PRODUCT CHANGE NOTIFICATION (PCN)

A-MCSP60005/B MODULAR CABLE

CHANGE NOTIFICATION: PCN 20220822_A-MCSP60005/B

DESCRIPTION OF CHANGES: CHANGE OF DATA SHEET
CHANGE OF DATA SHEET
New Draw.-No. ASS_7542_CArev06

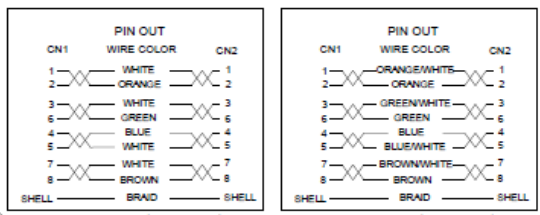
⑥ *The PIN OUT is applied to cable length $\ge 10M$ *The PIN OUT is applied to cable length $< 10M$

Scale	FREE	⑥	Add a PIN OUT for cable length $\ge 10M$	19.08.2022	Luca		Date	Name	Customer-No.
TOLERANCE		⑤	Add length code	29.06.2022	Luca	Drawn	01.02.2016	Joanna	ASSMANN WSW-No. A-MCSSP60XXX/X
		④	Change the plant	12.04.2022	Luca	Approved	19.08.2022	Luca	
		③	Update the cable description	01.11.2018	Segal				
DIM		TOL	②	Clarify the tolerance	23.08.2018	Segal			
			①	Add Grey color order code	11.08.2016	Ray			
Angle		TOL	Id.	Modification	Date	Name	Replace	Sheet
